Technical Service Bulletin (TSB)

Umbrella Valve Seal Missing From Cylinder Head Cover

REFERENCE:	TSB: 09-017-26 REV. A GROUP: 09 - Engine	Date:	August 19, 2026	REVISION:	09-017-26
VEHICLES AFFECTED:	2026 - 2027 (WL) Jeep Grand Cherokee / Grand Cherokee L This bulletin applies to vehicles built on or before August 15, 2026 (MDH 0815XX) equipped with a 2.0L Hurricane 4 Turbo W/ESS (Sales Code EC7).			MARKET APPLICABILITY: ☒ NA☐ MEA ☐ EE☐ IAP ☐ SA☐ CH NOTE: This bulletin applies to North America markets.	
CUSTOMER SYMPTOM:	Customer may experience a MIL-ON and/or an indication of low engine oil level. Upon inspection the technician may find the following: 1. One or more of the following Diagnostic Trouble Codes (DTCs) have set: - P0300-00 - Random/Multiple Cylinder Misfire Detected. - P0301-00 - Cylinder 1 Misfire. - P0302-00 - Cylinder 2 Misfire. - P0303-00 - Cylinder 3 Misfire. - P0304-00 - Cylinder 4 Misfire. 2. Engine oil level is low. IMPORTANT! If none of above symptoms are present, this TSB does NOT apply.

Fig. 1
Oil Level Inspection

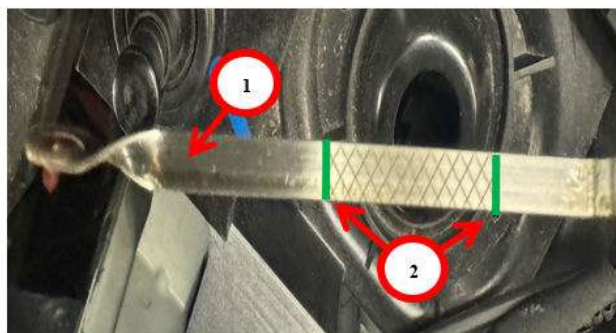
1. Inspect the engine oil level [Fig. 1](#).

2. Is the oil level low [Fig. 1](#)?
 - YES>>> Proceed to [Step 3](#).
 - NO>>> This bulletin has been completed. Use Inspection LOP 09-35-20-98) to close the active RSU.
Refer to service library for further misfire diagnosis.

Fig. 3
Approved Zone - PCV Valve Removal

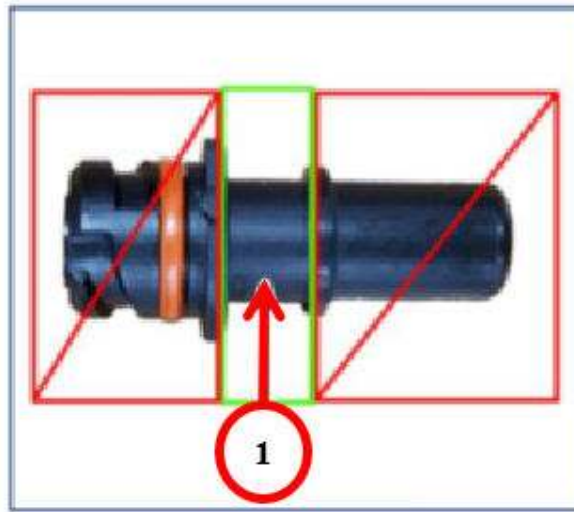
NOTE: Use a pair of thin nosed pliers inserted into the approved zone on the PCV valve for removal [Fig. 3](#).

Fig. 4
Borescope to PCV Valve Opening

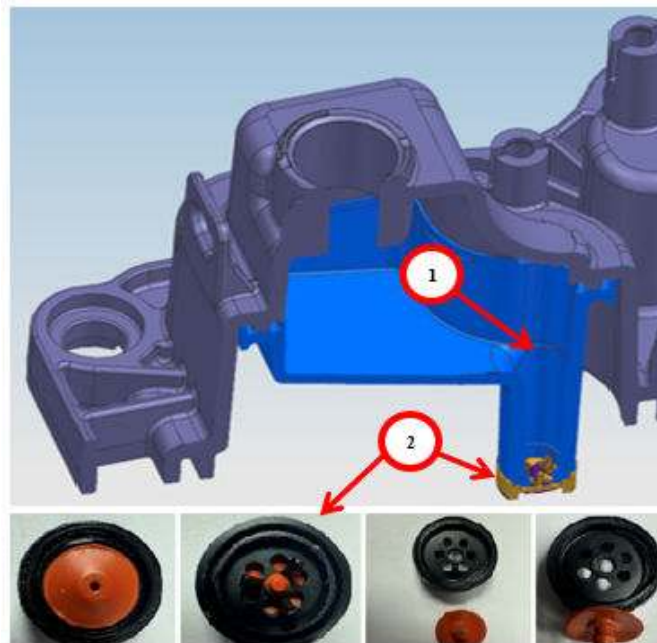
4. With the PCV valve removed, insert a borescope into the PCV valve opening [Fig. 4](#) to inspect if the umbrella valve is missing or present [Fig. 5](#) [Fig. 6](#).

5. Is the umbrella valve seal missing [Fig. 5](#)?
 - YES>>> Replace the cylinder head cover assembly. Refer to the detailed service procedures available in DealerCONNECT/Service Library under: Service Info> 09 - Engine, 2.0L / Cylinder Head / Cover(s), Cylinder Head / Removal and Installation and then proceed to [Step 6](#).
 - NO>>> This bulletin has been completed. Use Inspection LOP (09-35-20-98) to close the active RSU.
Perform further oil consumption diagnosis as required.
6. Ensure that the engine oil level is to proper specification.
7. **Using wiTECH, perform the PCM Reset ECU routine. Navigate to **Guided Diagnostics > Reset ECU**, select **PCM**, and follow the on-screen instructions to complete the procedure.**
8. Clear DTCs.
